ARCHITECTURAL REVIEW BOARD MEETING AGENDA

MEMORANDUM

Subject: ARB #23-016 1155 Herndon Parkway, Herndon Virginia

This staff memo is an addendum to the staff report for ARB #23-016 provided to the Board prior to the October 4th work session and subsequent staff memos provided to the board prior to the October 18th public hearing and the November 1st work session, and the November 15th public hearing.

REDESIGNED CORNICE APPLIES ON ALL TOWNHOME ELEVATION TYPES T,U,W,X

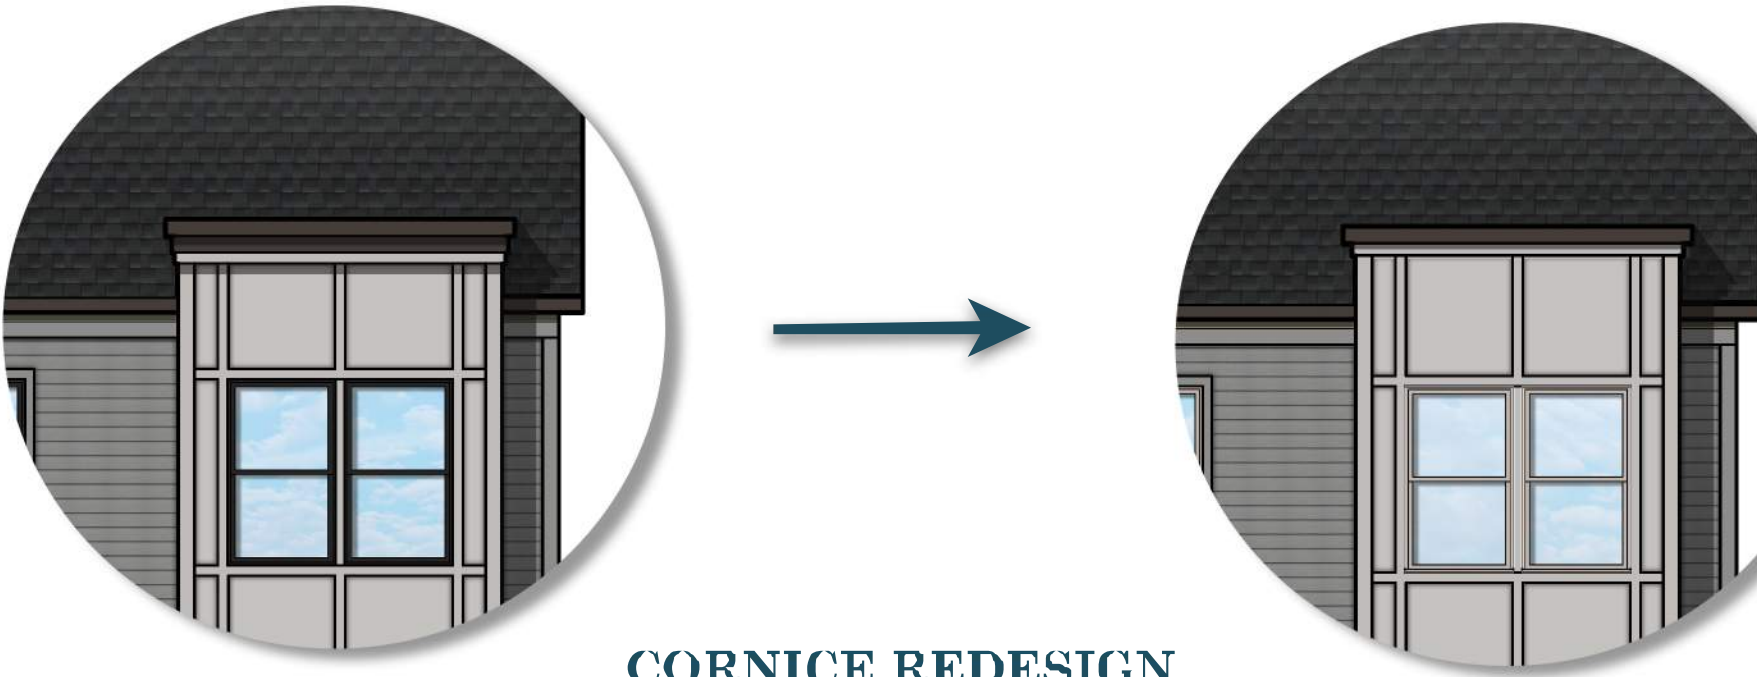
4. Cornice / Partial Parapet. The applicant included in the updated materials an altered cornice design aimed at addressing the Board’s comments regarding the stylistic and architectural incongruity between the gable and the narrow partial parapet or cornice. The altered design can be found on page two of Attachment #3.

The cornice or parapet is altered by removing one ridge of molding from the cornice, otherwise retaining the size, shape, and design. Staff believes that the alteration does not address the concern expressed by staff and the Board and notes that the designs do not address feedback regarding townhouse Elevation T also where the false parapet / cornice ends a short distance on either side leaving a narrow strip of lap siding on either side and requiring that the windows on this level are misaligned with the lower two levels. These items have been the subject of several discussions between the applicant and the Board, and between the applicant and staff.

The Board is tasked with determining “*Whether or not the combination of architectural elements proposed for a structure, building or improvement, in terms of design, line, mass, dimension, color, material, texture, lighting, landscaping and roofline and height conform to accepted architectural principles. . .and exhibit external characteristics of demonstrated architecture and aesthetic durability.*” Staff does not believe the designs that include these features as proposed meet this criteria and is not likely to recommend approval as

currently proposed. Staff has asked in the past for the applicant to submit images of completed developments where this design element or a similar design element has been used successfully. This would be helpful for the Board and staff to understand the design and how it has been successfully used elsewhere.

- Flatten the roof, or if the side gable must be retained, extend the flat cornice or parapet across the whole frontage to give the illusion of a flat roof.

- Alter the flat cornices into front facing gables to integrate stylistically with the side gable design.
5. Retaining Walls. The applicant has provided specification sheets and example images for the four retaining walls that will be located throughout the development. While retaining wall dimensions and location are determined by code requirements and are outside the ARB's purview, the treatment of retaining walls is a matter the Board should consider. Staff believes that the information provided by the applicant is sufficient and that the materials meet the Design Criteria set out in the Town of Herndon Zoning Ordinance.

ALL AVAILABLE PARK PLACE ELEVATIONS

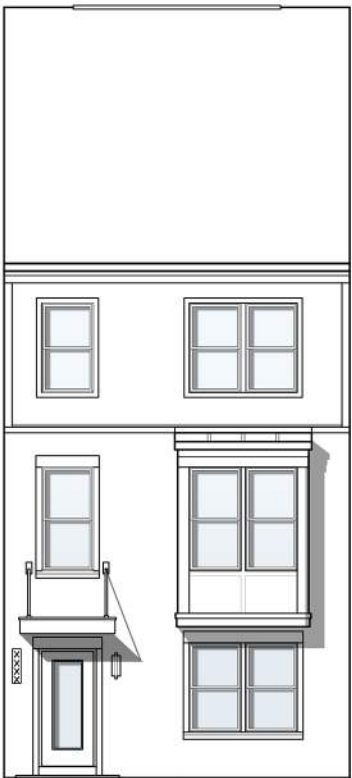
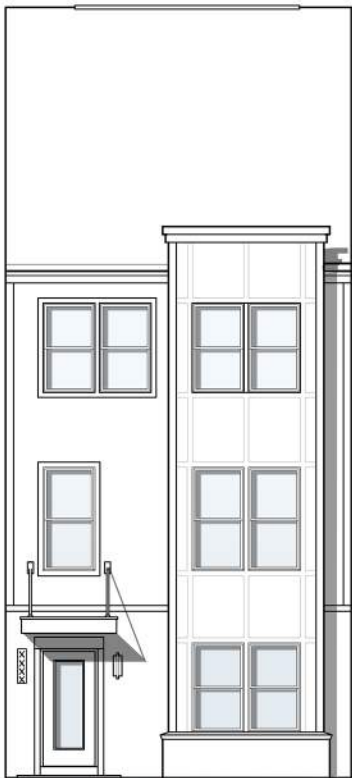
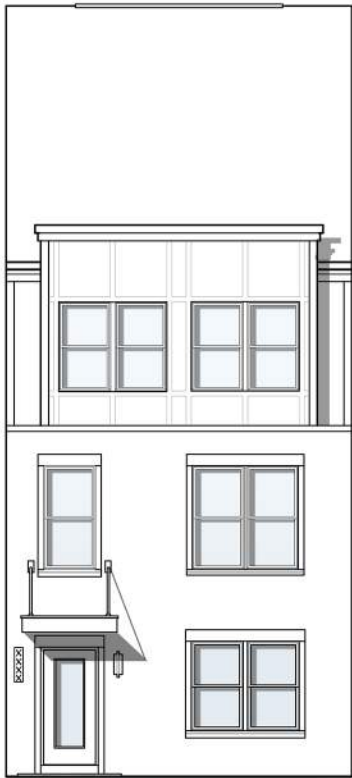
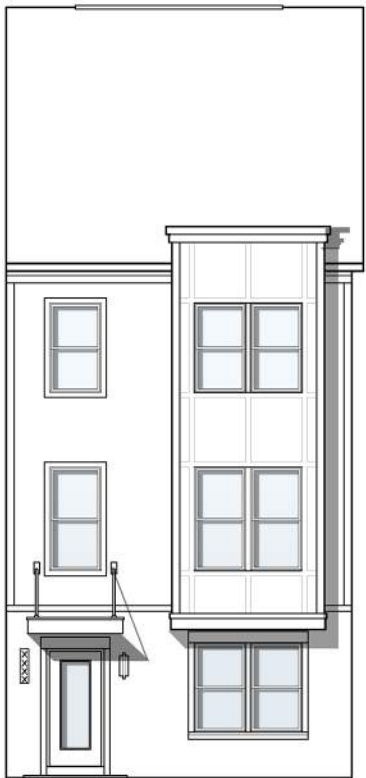
2. Elevation Drawings. Attachments #1, #2, and #3 include elevation line drawings and color elevation drawings of four townhouse designs and three 2-over-2 structure designs. Staff understands that these constitute all design options that will be a part of the Park Place development. This is a very limited number of designs for a development that consists of 55 townhomes and 56 two-over-two units. Though the total number will be broken up into sticks or rows of three to

nine groups, this presents serious concerns regarding the level of repetition this will dictate within the development. Staff recommends including one or two more design options for townhouses and the same for the 2-over-2 structures, and encourages the Board to discuss ways to ensure as little repetition as possible such as requiring no more than two of the same design within one row, or no two adjacent properties can be of the same design. In the past, the ARB has added similar conditions of approval to applications of this type.
